STATE OF MAINE
DEPARTMENT OF TRANSPORTATION
16 STATE HOUSE STATION
AUGUSTA, MAINE
04333-0016

January 18, 2007
Subject: **Topsham**
Pin No. 14062.11
Amendment No. 4

Topsham
14062.11
Highway Maintenance Garage
January 16, 2007

TITLE
BUILDING ELEVATIONS

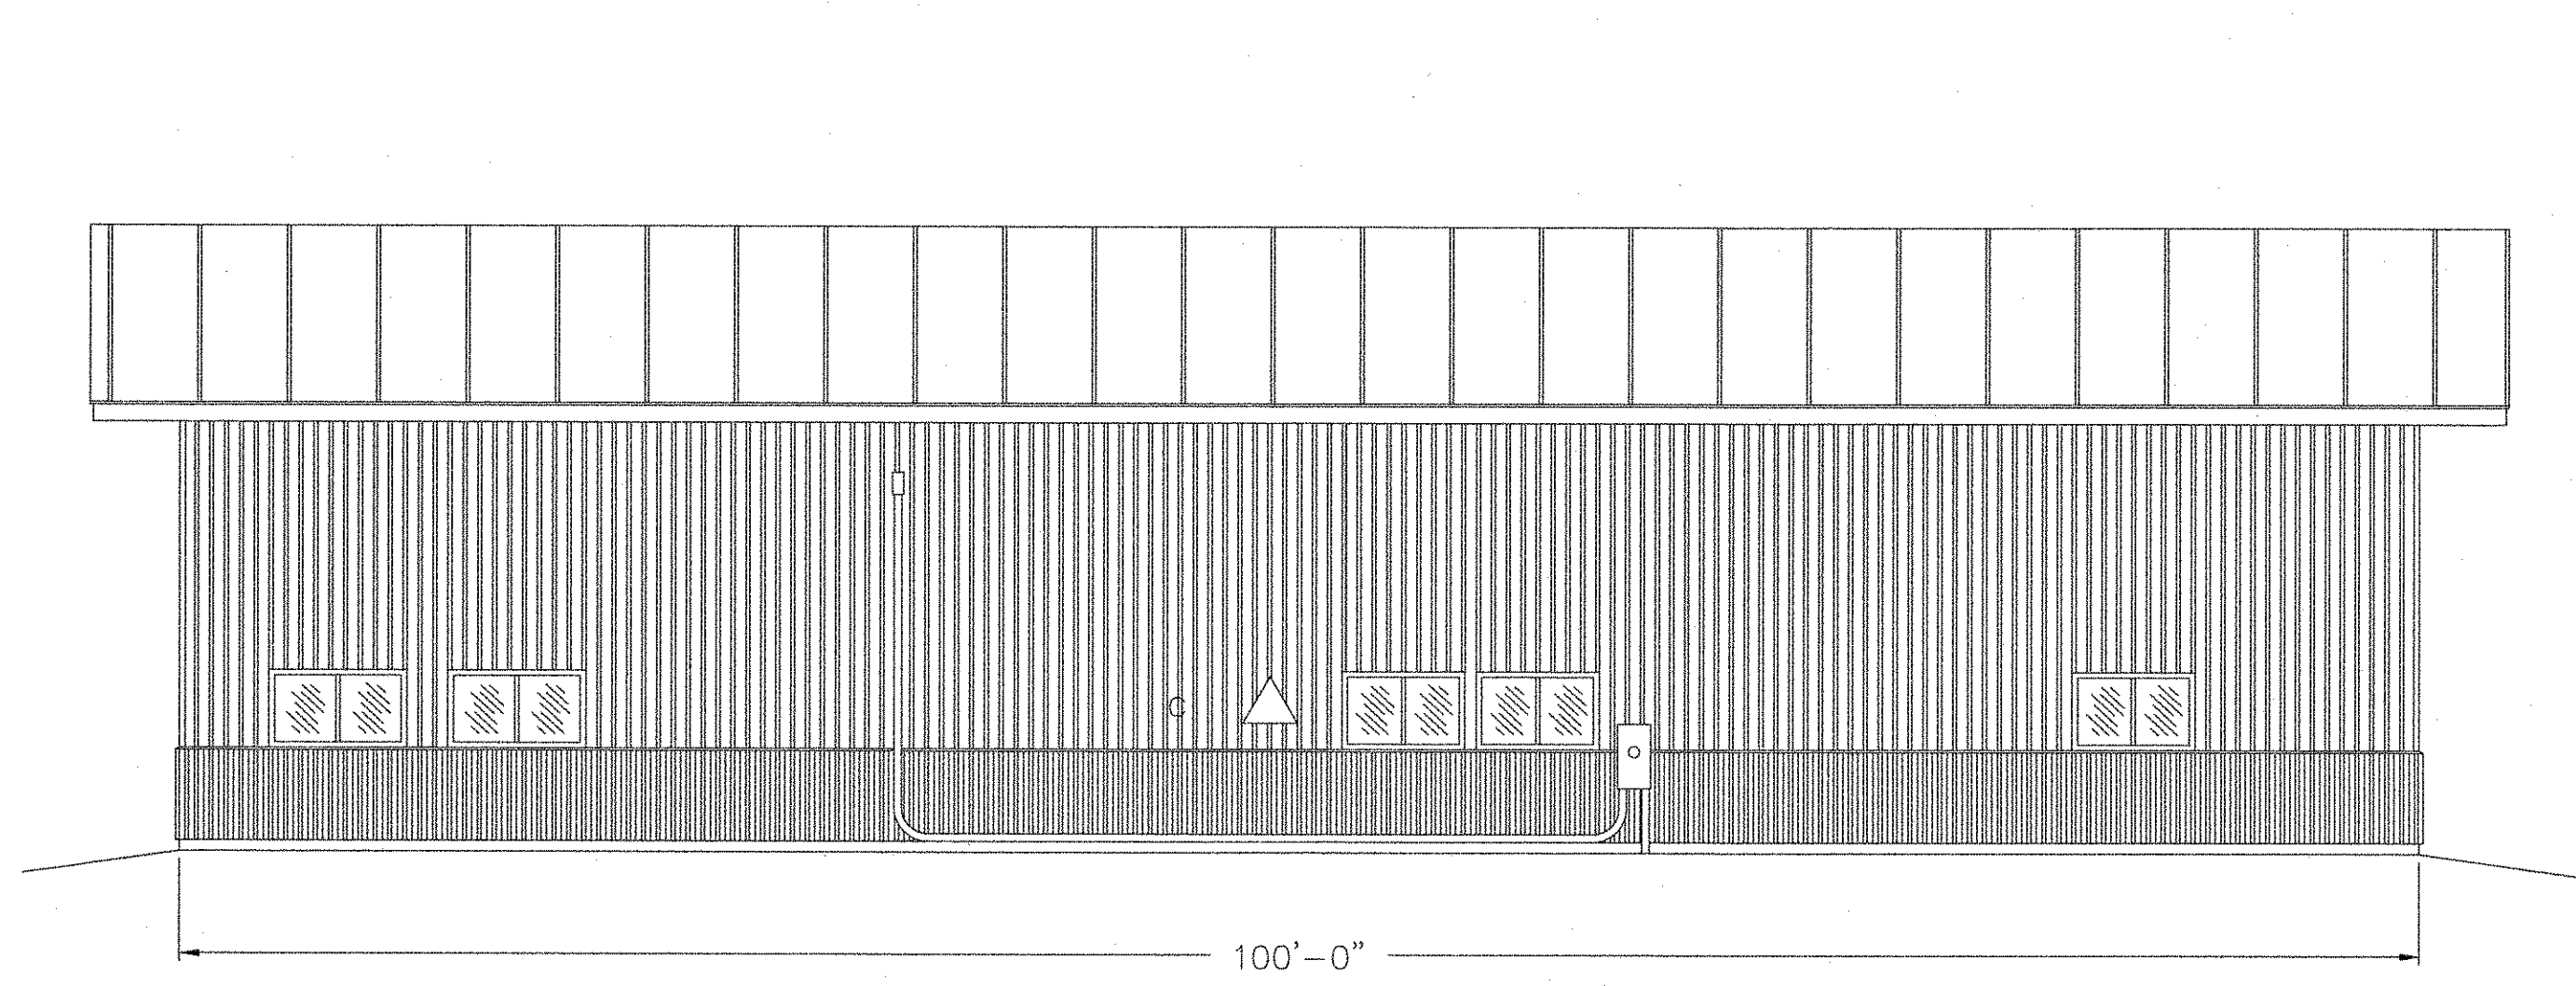
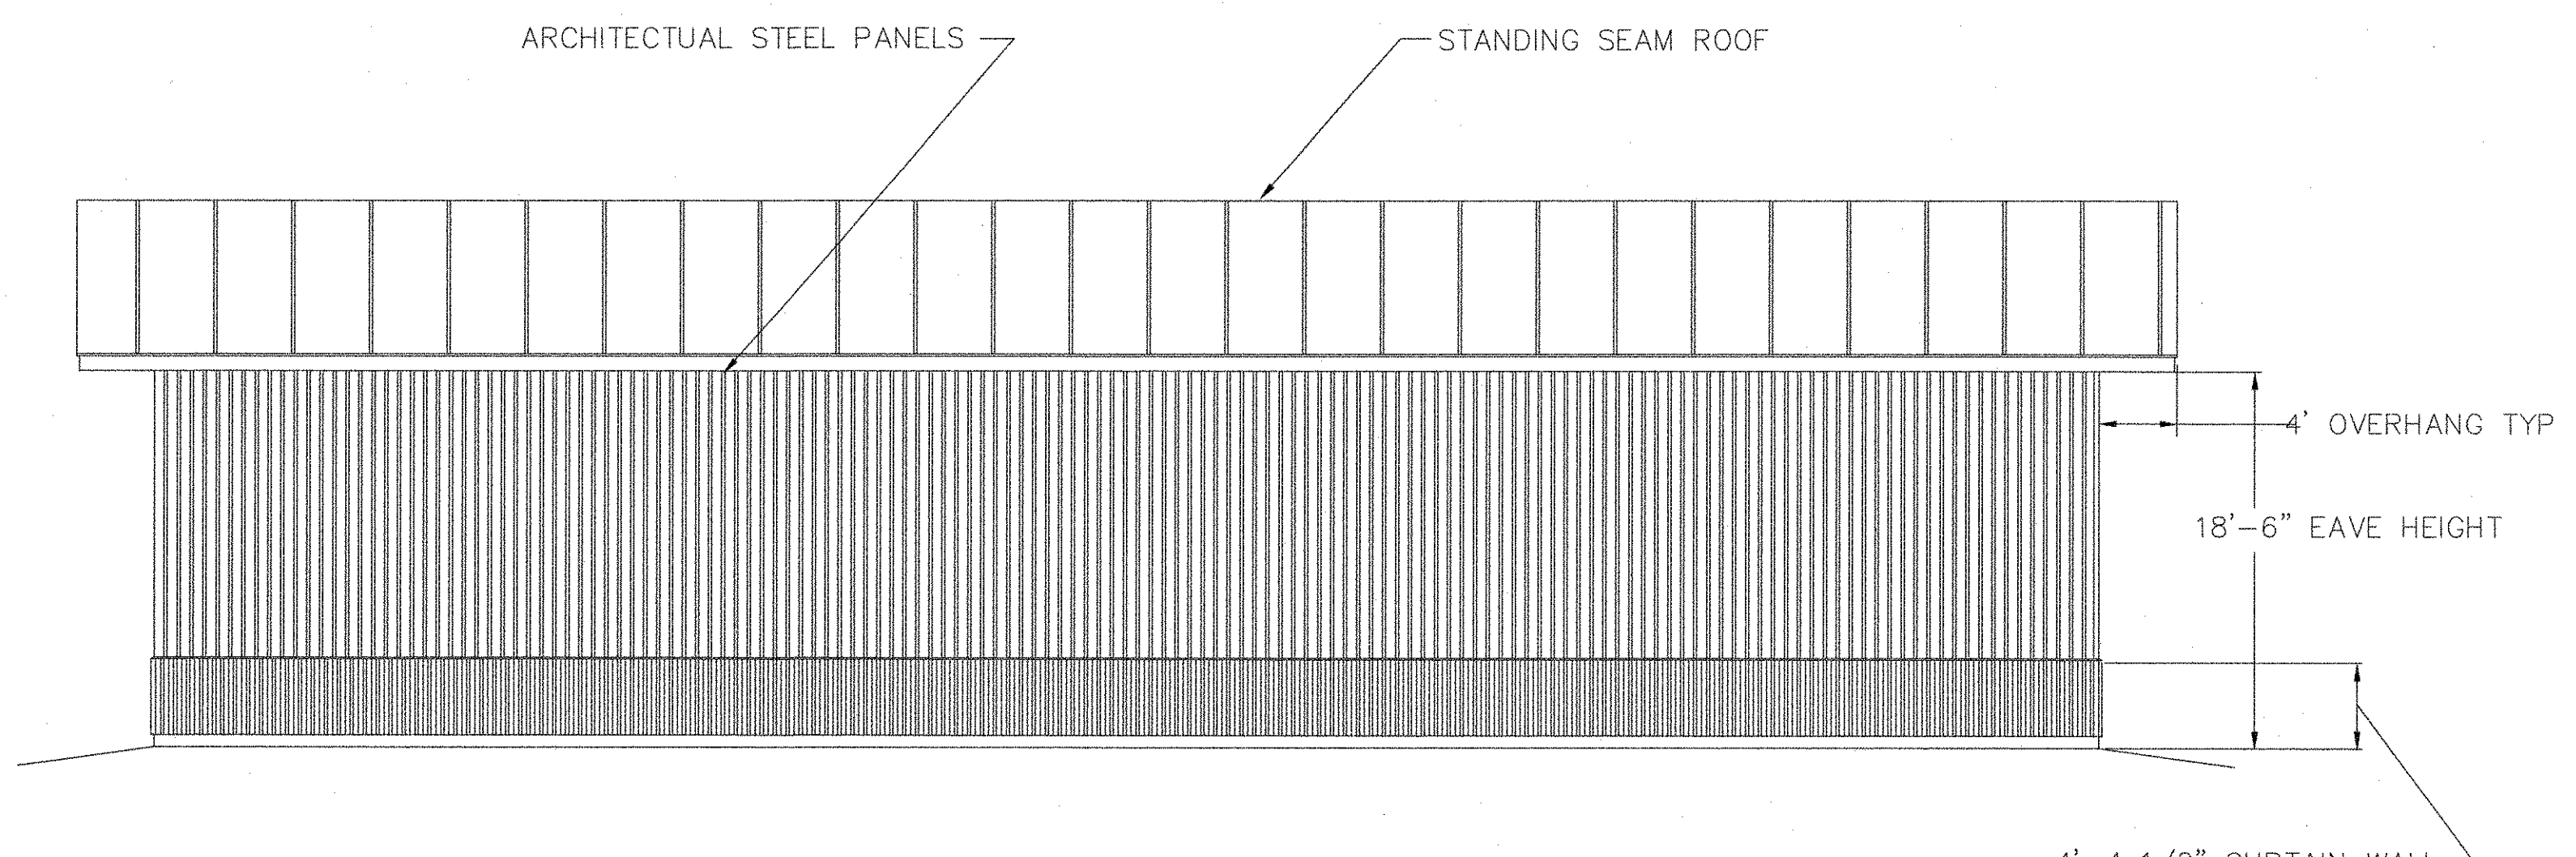
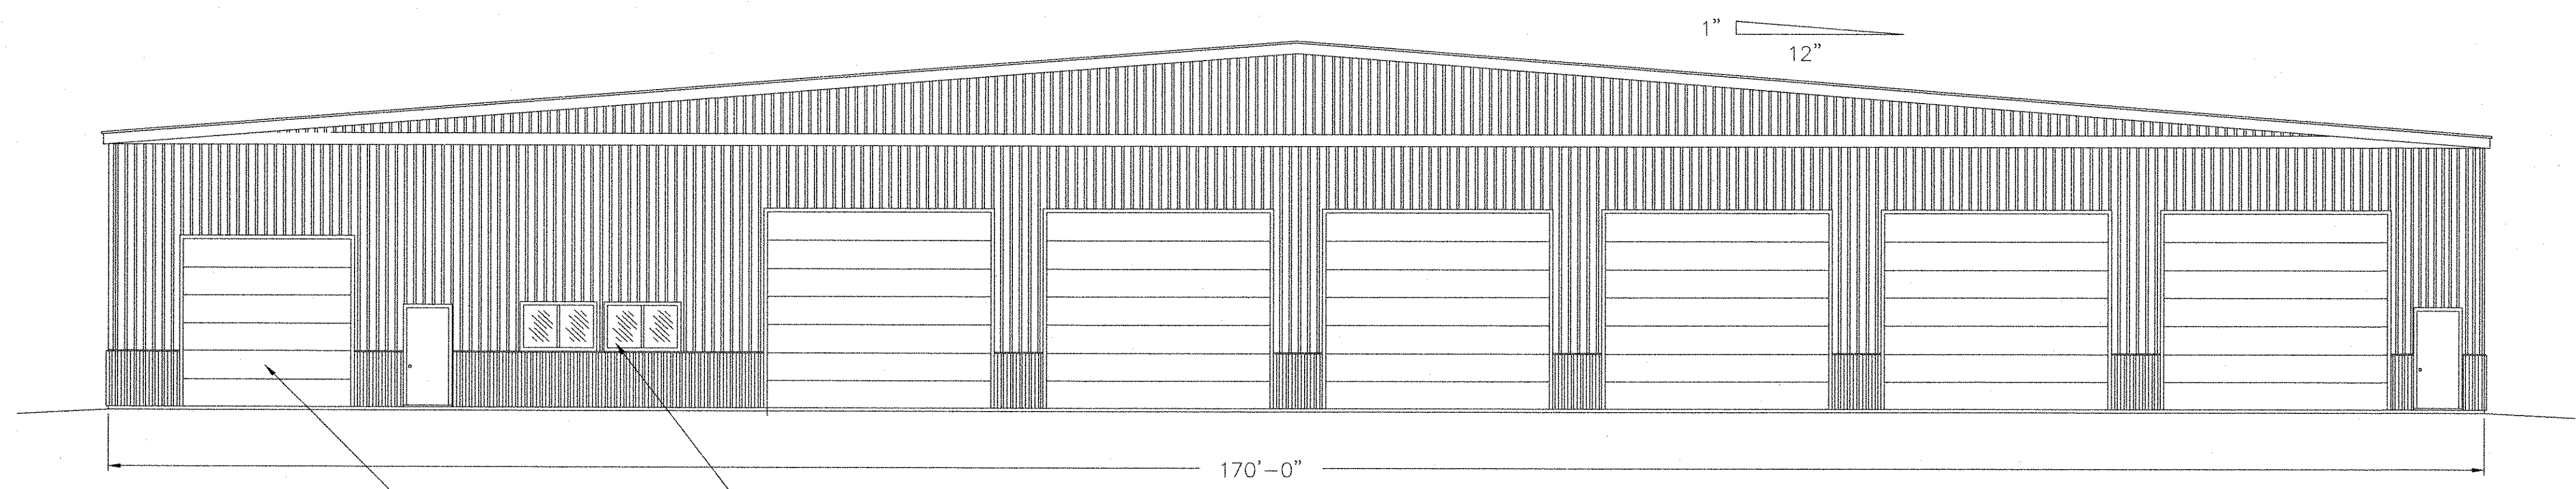
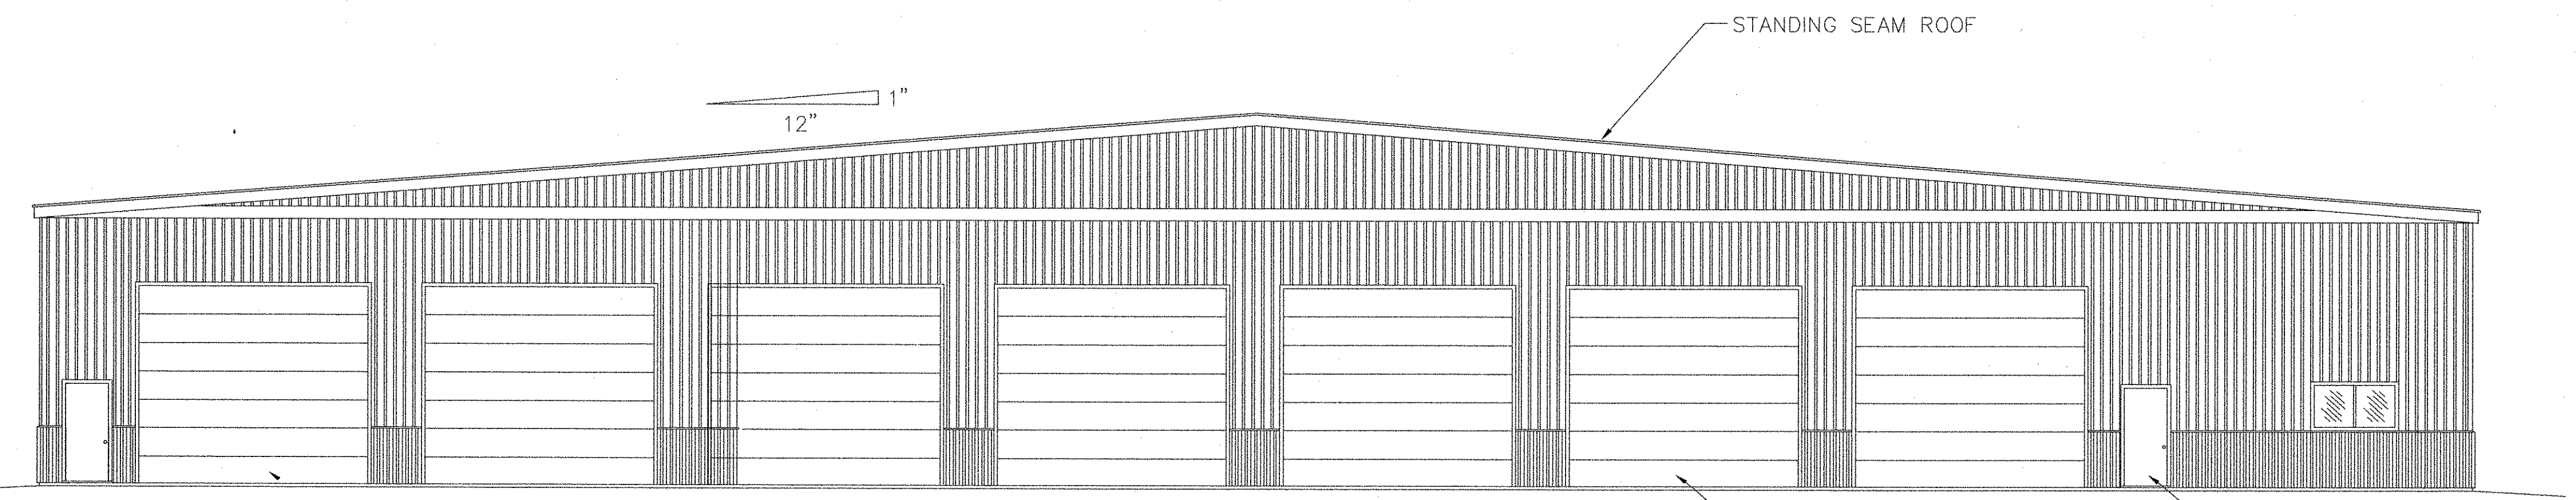
REMOVE the existing plan sheet A-2B, “Building Elevations” and replace with the attached updated “A-2C, Building Elevations”.

Question: Drawings on the south elevation show a window where a main frame column is.

Question: Elevations on the drawings appear to show panel on the 4' concrete wall. Is this correct?

Question: On drawing A-2, the north elevation has a detail that reads "4' - 4 1/2' curtain wall behind sheathing." What does this mean? Please provide detailed cross section.

Response: The window has been removed.

Response: Yes. See attached Curb Wall Sections drawings provided in this amendment.

Response: See attached Curb Wall Sections drawings provided in this amendment.
